# North York Moors National Park Authority

## 08 February 2024 Planning Committee members update sheet

**APPLICATION - NYM/2023/0868**

Application is to vary Condition 2 (retrospective) - to regularise approved drawings with the as-built extension.

Fig 1A: The approved Planning Drawing with key dimensions shown.

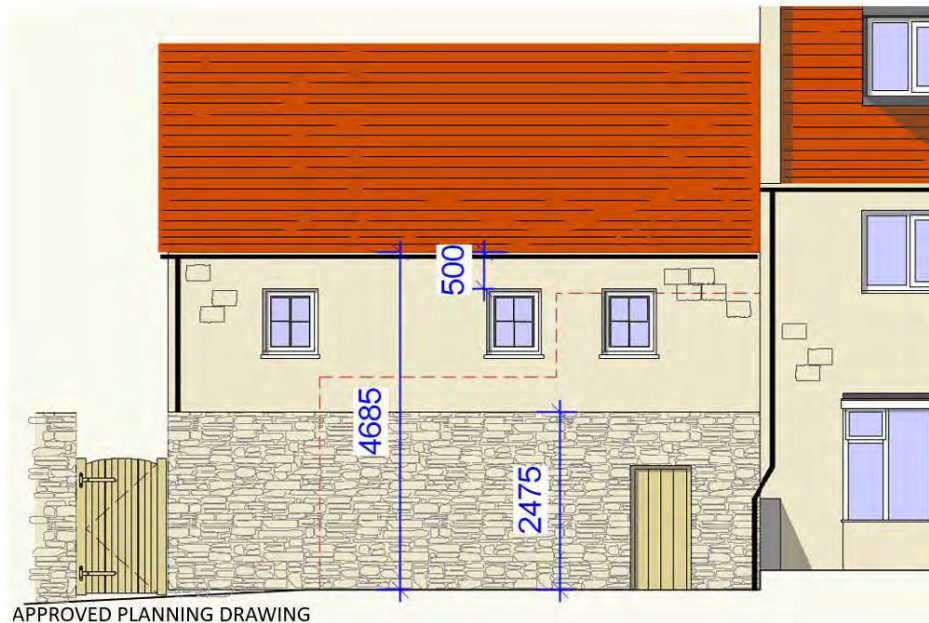
As previously mentioned, the constructed extension is not taller than the approved design, as follows:

Approved Design (mm)	As Built (mm)
Ground to Eaves	4685	4610
Ground to Ridge	7000	6900

I understand that you have acknowledged these dimensions previously (and have visited site) but raised concern regarding the comparative levels between the constructed extension and the existing building, for example on the approved drawings the eaves of the extension are shown to be level with halfway up the existing first floor window, whereas the built extension's eaves align with the top of the existing first floor window. Approximately a 430mm rise. The reason this has happened is to do with the position of the extension. As follows:

The approved design placed the extension further forward, just 650mm back from the existing building's front elevation. When we began installing the foundations for the extension, a neighbour verbally raised a boundary concern. We decided to listen and to appease the situation moved the front wall of the proposed extension back to 1220mm behind the existing front elevation, hence some of the reduction in footprint. However, the ground inclines from the front to the back of the plot, meaning that when we moved the extension back the vertical position of the extension moved up slightly. This was my genuine error, for which I apologise. I realise now that I should have dug deeper into the ground to set the extension at a consistent level of altitude. Instead, I focussed on ensuring the ground to eaves height remained as approved and missed that the overall building had 'gone up the hill' slightly. This has made the comparative levels of the extension appear higher against the existing building. Figures 1A and 1B demonstrate the comparison directly and show the relevant dimensions. The drystone wall in Figure 1B has been photoshopped to show it complete, which will be done very soon. Hopefully this week, weather permitting.

Fig 1B: Photograph of the constructed extension. The drystone wall has been photoshopped to appear complete. Completion of the stone wall will hopefully take place shortly. This week weather permitting.

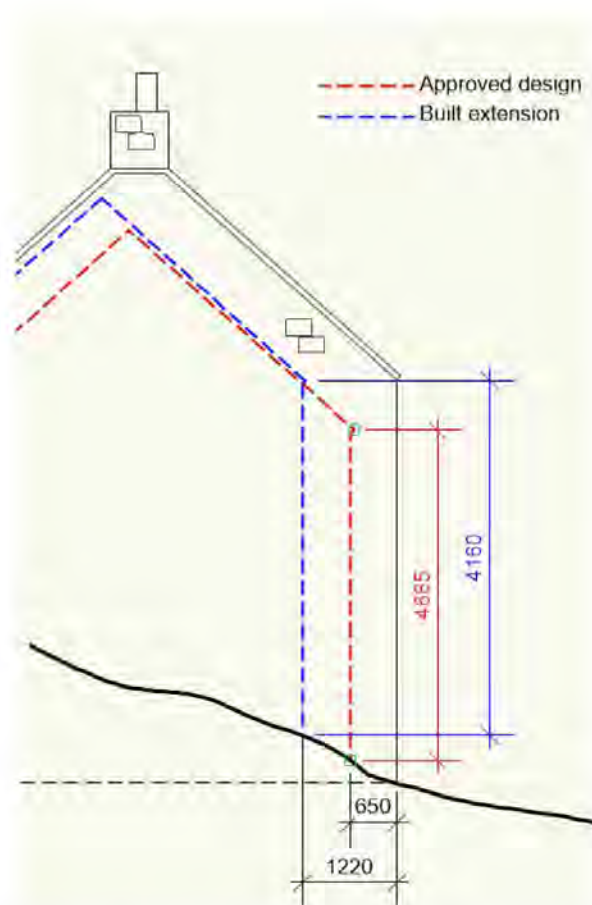
Currently incomplete, but we will progress the completion of the drystone wall to its approved height shortly (hopefully this week weather permitting), which will make a huge difference to the visual

appearance of the elevation. I have included a 'photoshopped' image below Figure 1E giving an impression as to the completed wall/elevation to the approved height.

**Fig 1: Approved Design** – This design is considered to enhance the character of the host building, be subservient and enhance the character of the setting, in-line with Policy CO17.

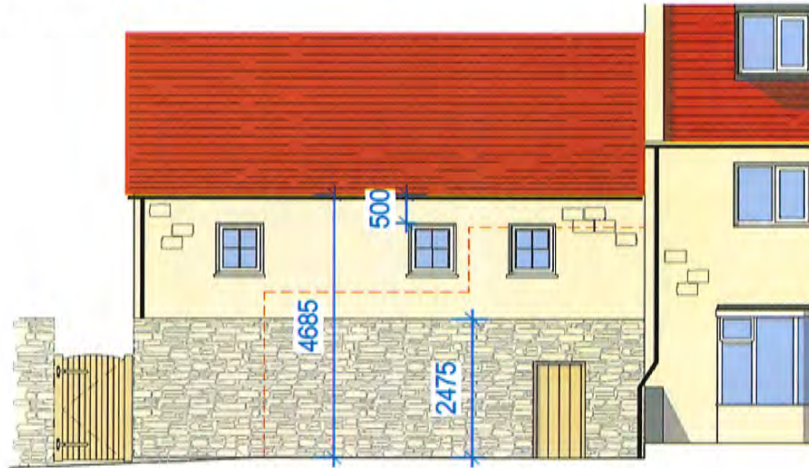
The as-built extension (shown below) is smaller than the approved design in terms of footprint, volume and overall size but is set 430mm higher against the host dwelling, due to a genuine error during construction.
